HISTORIC AND DESIGN REVIEW COMMISSION

HDRC CASE NO: 2022-476
ADDRESS: 2014 W KINGS HWY
LEGAL DESCRIPTION: NCB 1942 BLK 30 LOT 25
ZONING: R-6 CD, H
CITY COUNCIL DIST.: 7
DISTRICT: Monticello Park Historic District
APPLICANT: Eric Graaf/EG Investment Group LLC
OWNER: Eric Graaf/EG Investment Group LLC
TYPE OF WORK: Fencing, fenestration changes
APPLICATION RECEIVED: September 09, 2022
60-DAY REVIEW: Not applicable due to City Council Emergency Orders
CASE MANAGER: Jessica Anderson

REQUEST:

The applicant requests a Certificate of Appropriateness for approval to replace two ganged wood windows with two 15-light wood doors and to construct a wood staircase from the new doors to the backyard.

NEW REAR ELEVATION

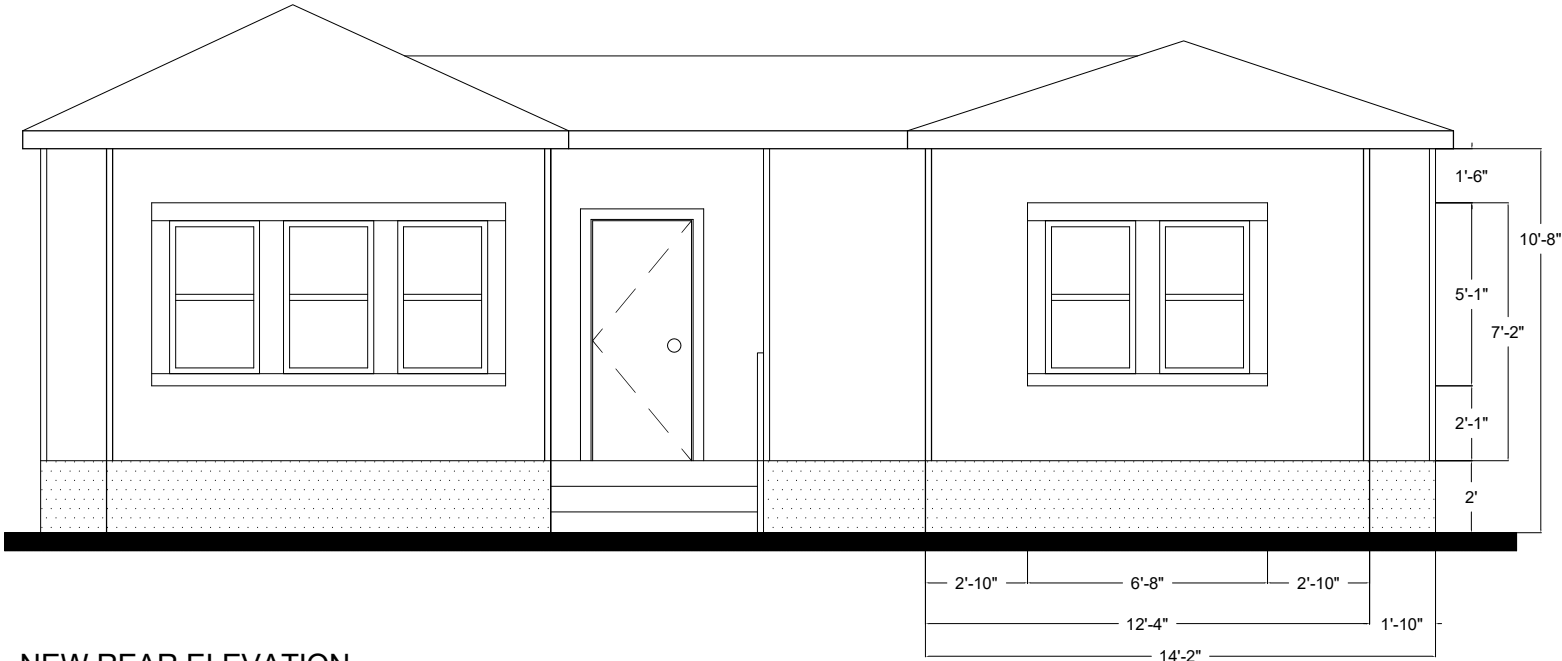
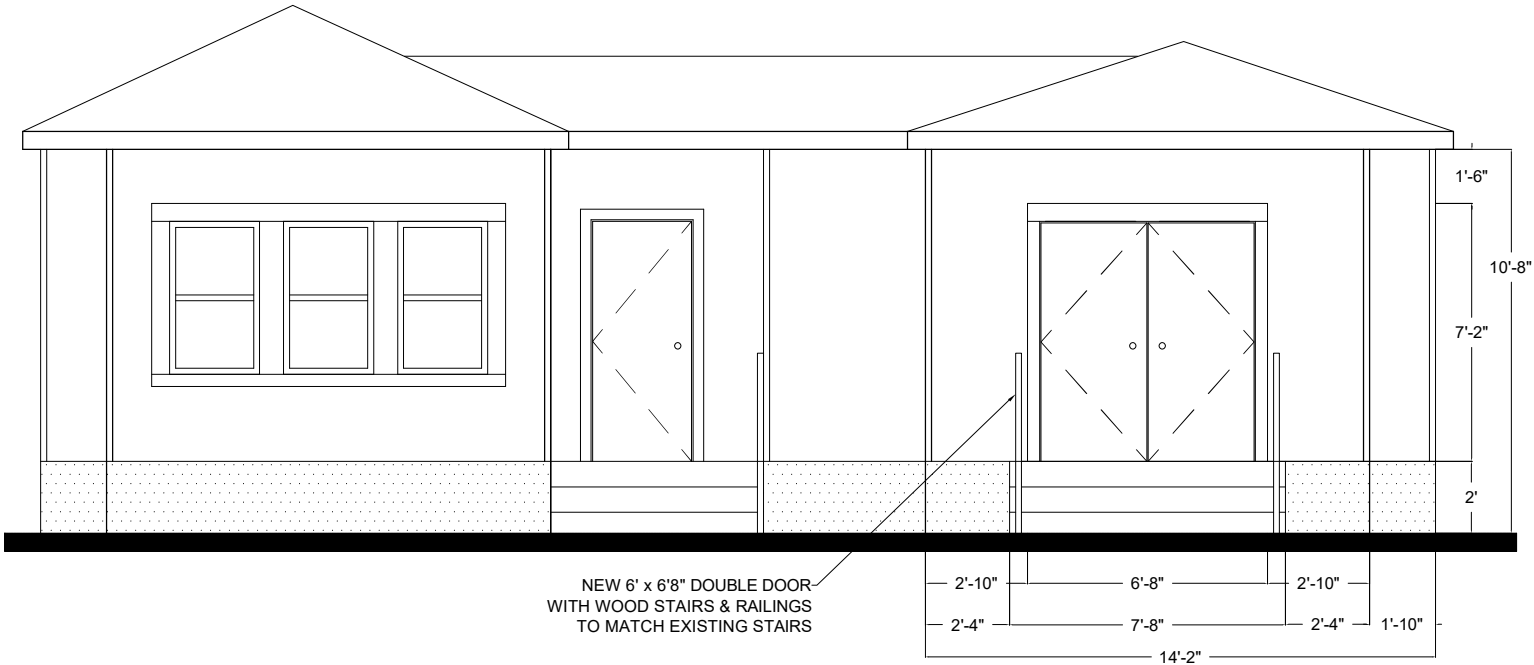
- c. DOORS: The applicant requests to replace a pair of ganged historic wood windows on the rear elevation of the primary house with a pair of 15-light doors with a staircase to the backyard. Historic Design Guidelines for Exterior Maintenance and Alterations 6.A.i states that existing window and door openings should be preserved. Staff finds the request does not conform to this guideline.

- d. DOORS (DESIGN): Guideline 6.B.ii says new entrances, when necessary to comply with other regulations, should be compatible in size, scale, shape, proportion, material, and massing with historic entrances. The applicant proposes replacing the existing wood windows with 15-lite double wood-frame doors. Staff find this generally appropriate but finds that the new doors should maintain the same head height as the historic wood windows.

- e. STEPS: The applicant proposes to construct a wood staircase from the proposed double doors to the yard. Staff finds this generally appropriate.

Staff recommends approval of the request to replace two ganged wood windows with two 15-light wood doors and to construct a wood staircase from the new doors to the backyard based on findings a through e, with the following stipulation:

- i. That the new doors feature the same head height as the historic ganged wood windows.
- ii. That the existing wood windows be salvaged and stored on site for potential future reuse.
